UNITED STATES PATENT AND TRADEMARK OFFICE

Office Action Summary

10/767,211

DETAILED ACTION

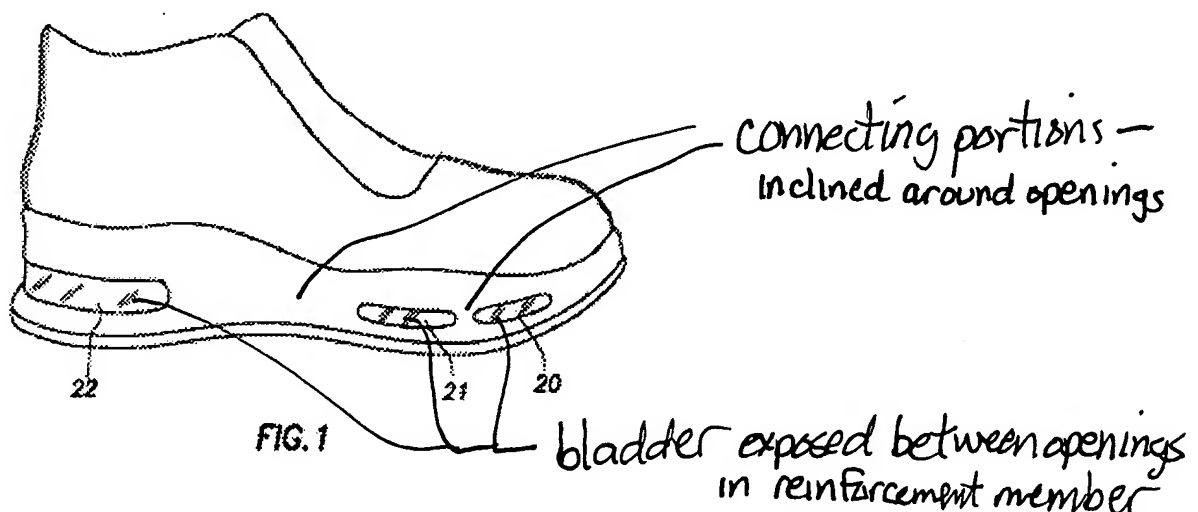
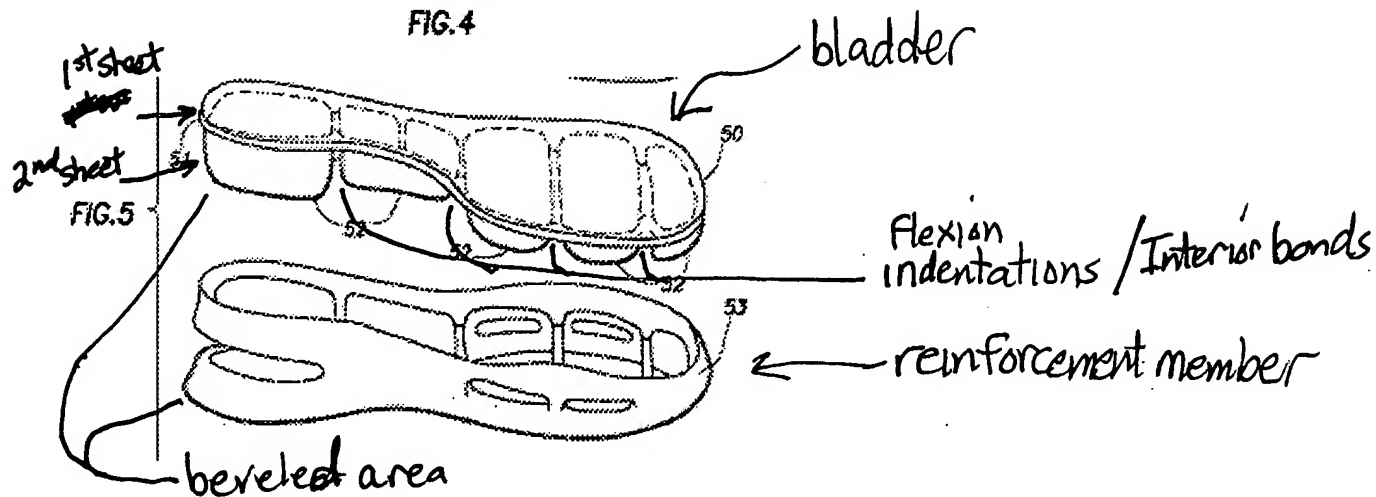
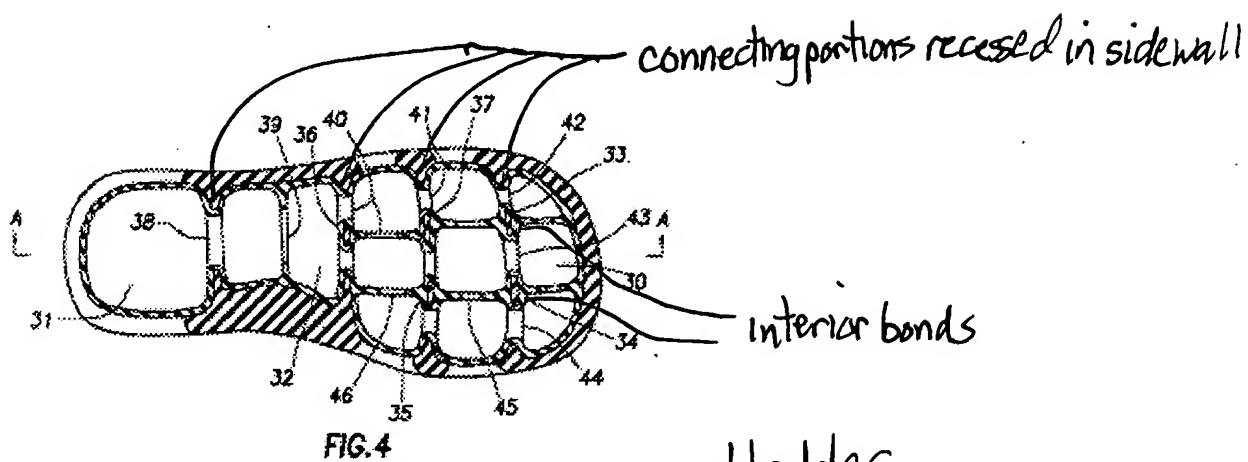
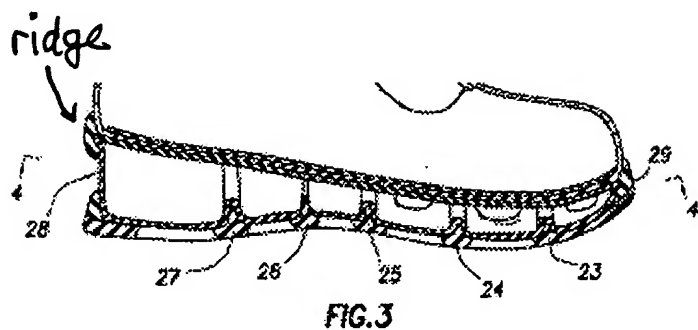
4. Claims 1,2,4-9,11,12,14,15,18-20,24,25,26,28-31,35,37-42,46-56,59,60-70,73-76,96-99 and 101-109 are rejected under 35 U.S.C. 102(b) as being anticipated by US 6009637 (Pavone). Pavone teaches an article of footwear comprising an upper and a sole structure as claimed; see the marked-up figures below. a sole component as claimed including a bladder and a reinforcing structure at least partially recessed into the barrier material as claimed. See the marked-up figures below. When the bladder is inflated to a certain point and/or there is a great enough force applied (i.e. the force created upon impact upon the wearer's foot) to the bladder, it will inherently place the connecting portions of the reinforcing structure in tension. When such a force is applied the sidewalls of the bladder will create an outward force and hence place the connecting portions in tension. Also, the reinforcing structure will inherently restrain distension of the surfaces of the bladder. Regarding claims 24 and 46, as understood, the outsole (54) of Pavone represent a second different material of the reinforcing structure.
